**NEBRASKA ARMY NATIONAL GUARD
CATS-M SIMULATOR BUILDING**

PROJECT NO. 31090391

A D D E N D U M N O . 1

BOLLARD DETAIL

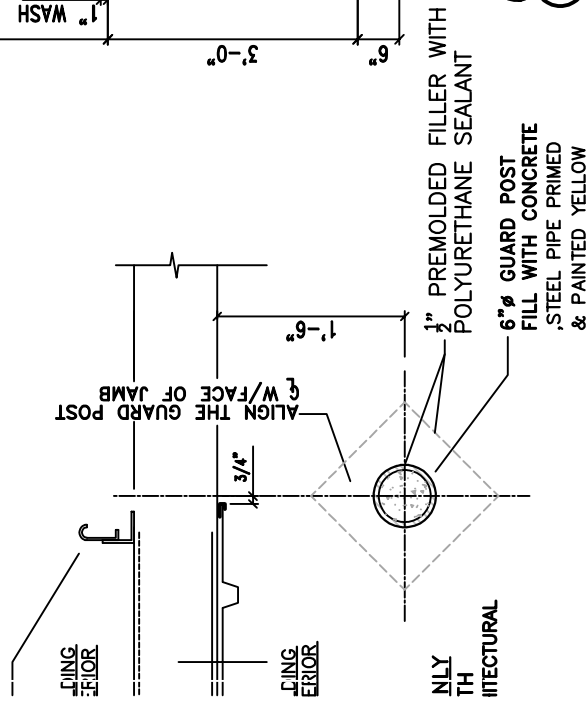
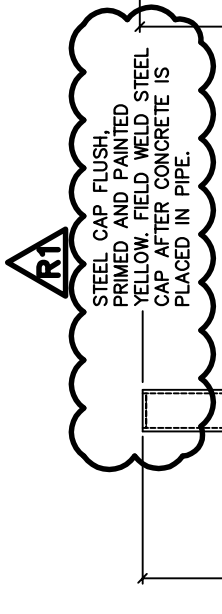
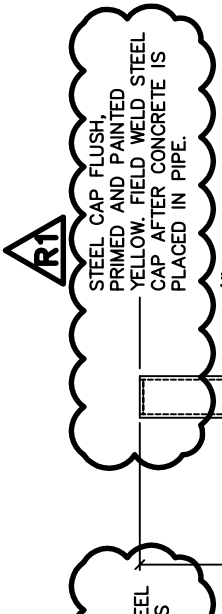
- ADD 1-1 Pre-Bid Meeting Sign-In Sheet. Refer to the attached sign-in sheet.
- ADD 1-2 Updated Nebraska Military Department Pre-Bid Conference Agenda. Refer to the attached Pre-Bid Conference Agenda.
- ADD 1-3 No additional addenda will be sent prior to the bid date.
- ADD 1-4 Furnish bollards with flush steel cap. Refer to attached drawing, C201.

ISSUED FOR:	DATE:	BY:
REVISED END OF BOLLARDS ON BOLLARD DETAIL	08/22/16	SDB

BOLLARD NOTE:
FOR BOLLARDS PLACED IN CONCRETE,
TOP OF FOOTING SHALL BE 18"
SQUARE.

Mead Training Site - Project Location

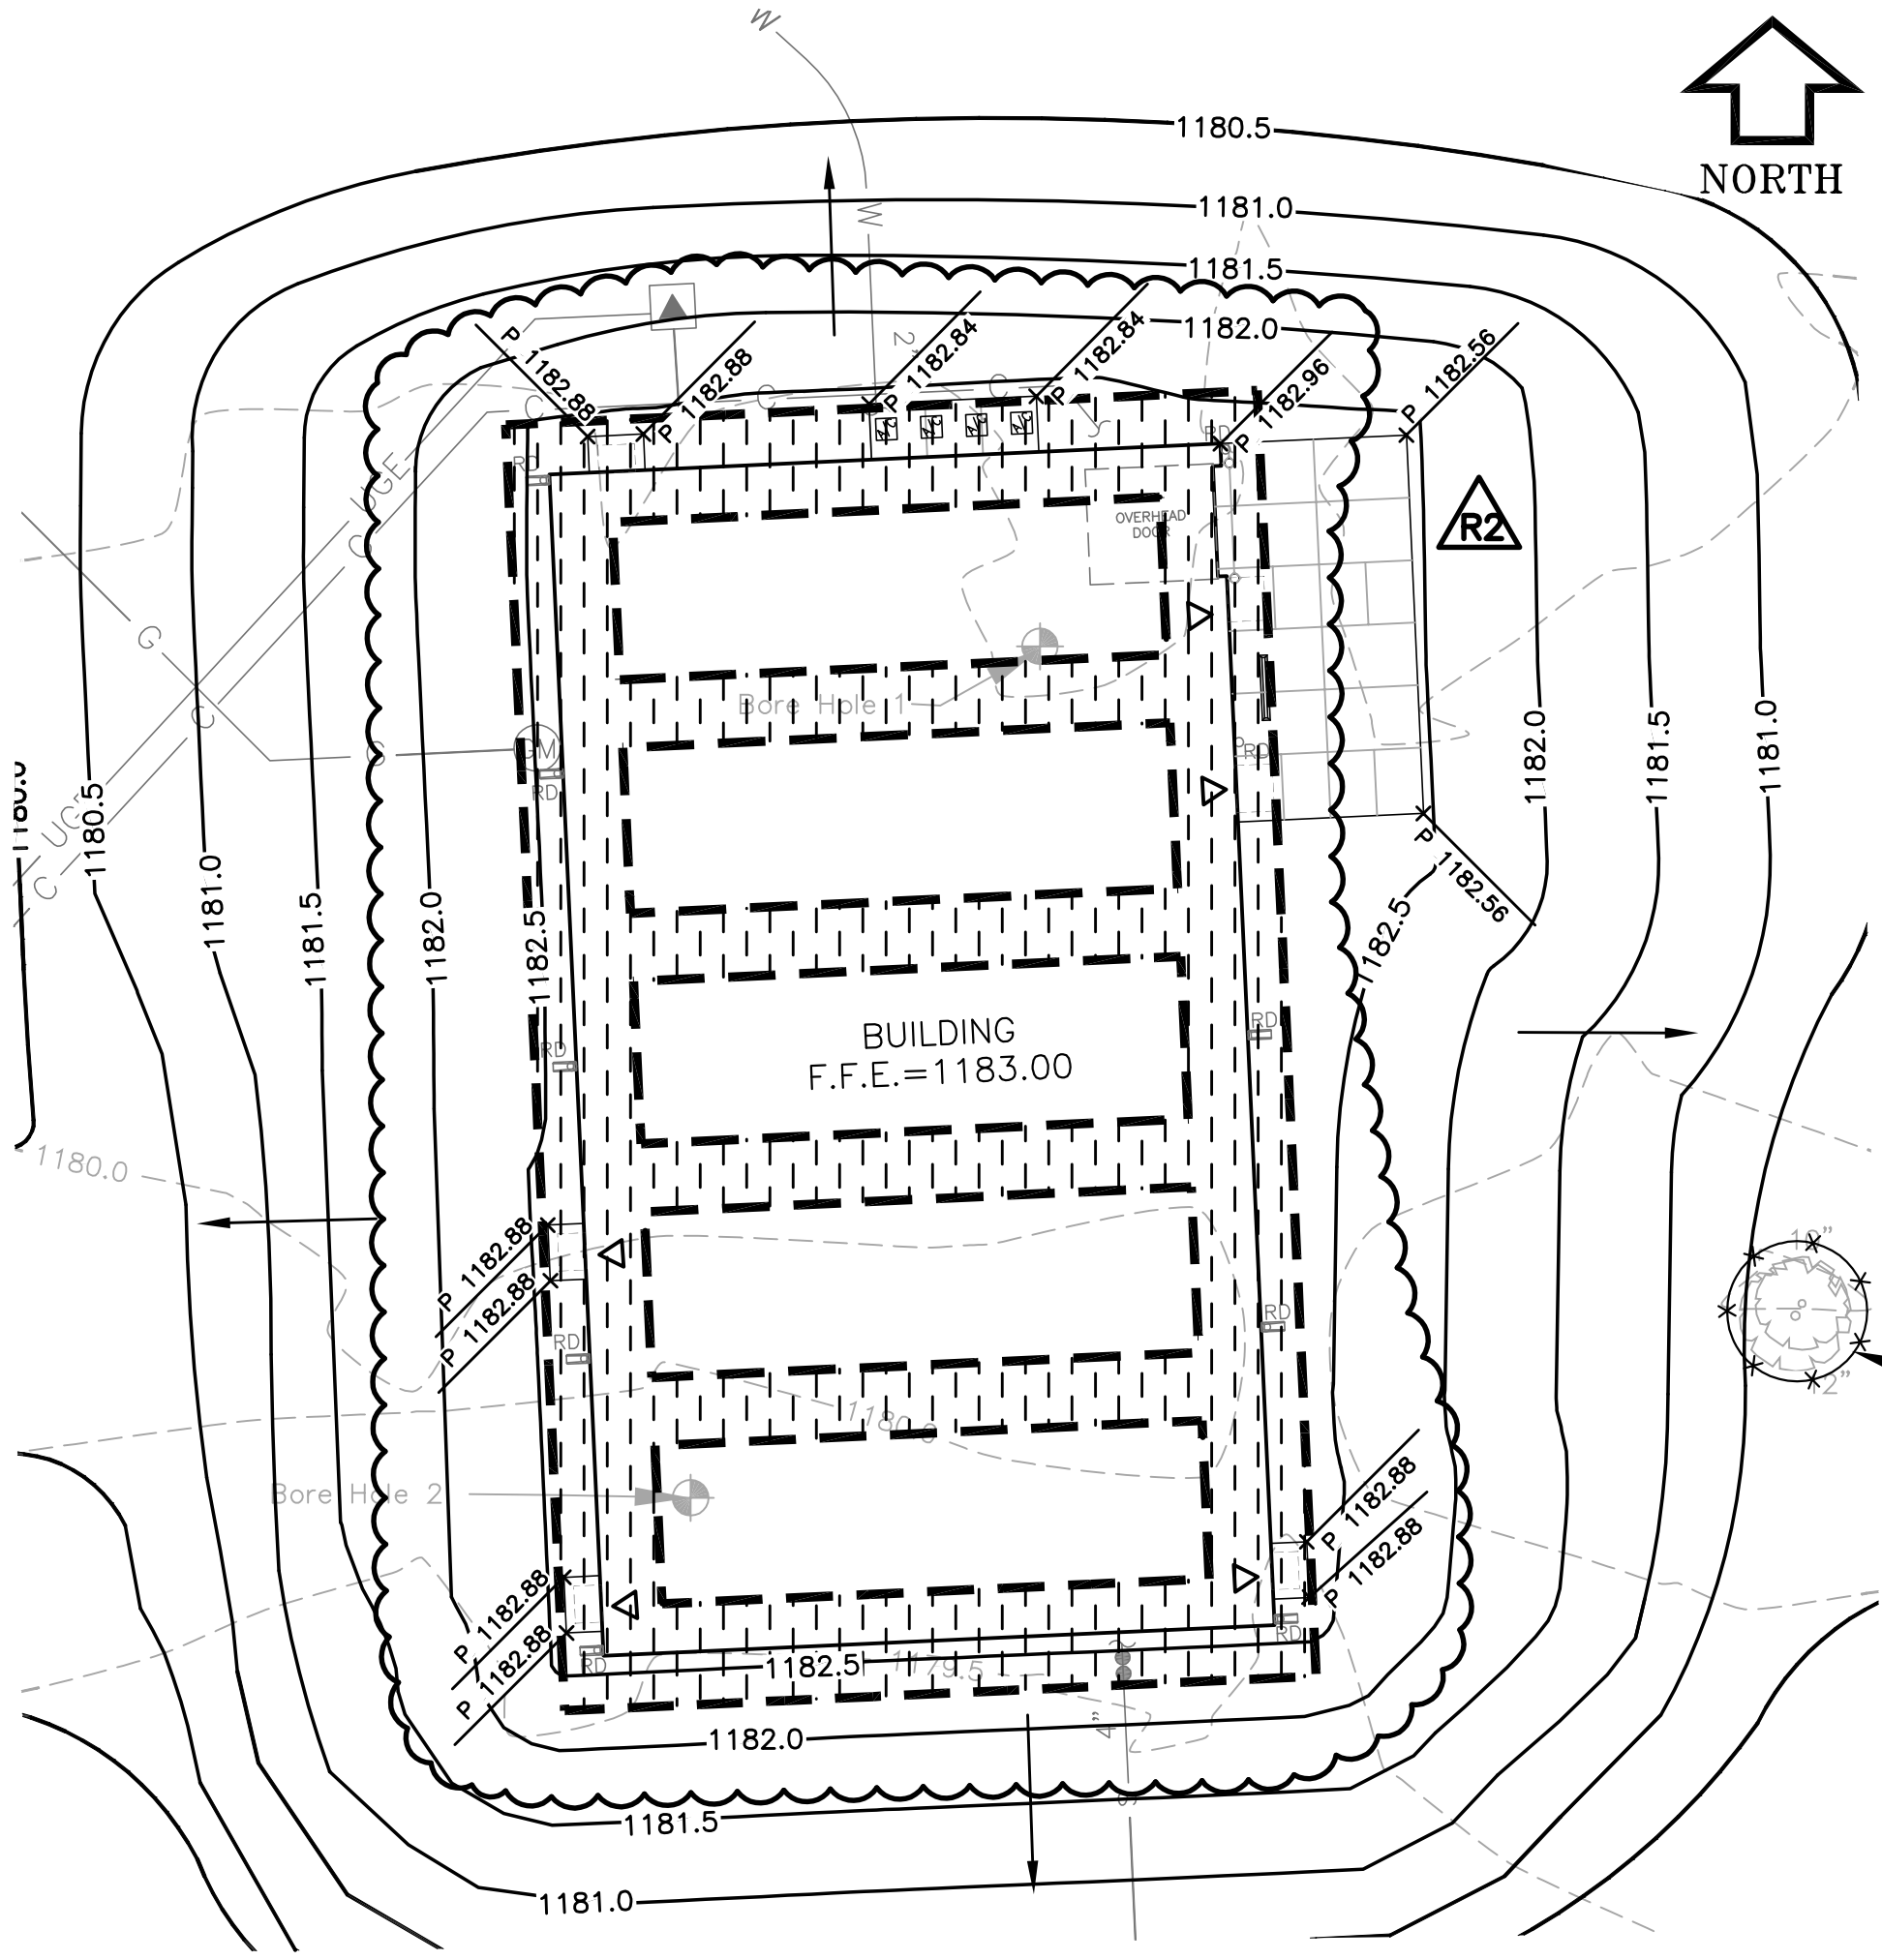
- ADD 1-6 See attached Geotechnical Soils Report for building site (23 pages).
- ADD 1-7 See attached aerial site plan for soil borrow pit location.
- ADD 1-8 See attached Grading Plan, C101 for revised site grading requirements.

GRADING PLAN

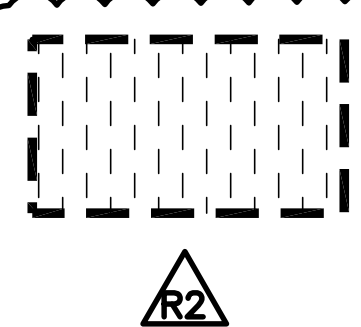
ISSUED FOR:	DATE:	BY:
ADDED OVER EXCAVATE INFO. TO PLANS AND LEGEND.	08/25/16	SDB

— OVER EXCAVATION LIMITS,
OVER EXCAVATE TO 3' BELOW
AND 3' OUTSIDE BUILDING
FOOTING. SEE THIELE REPORT
NUMBER 16299.02 DATED
AUGUST 17, 2016 FOR
FURTHER INFORMATION.
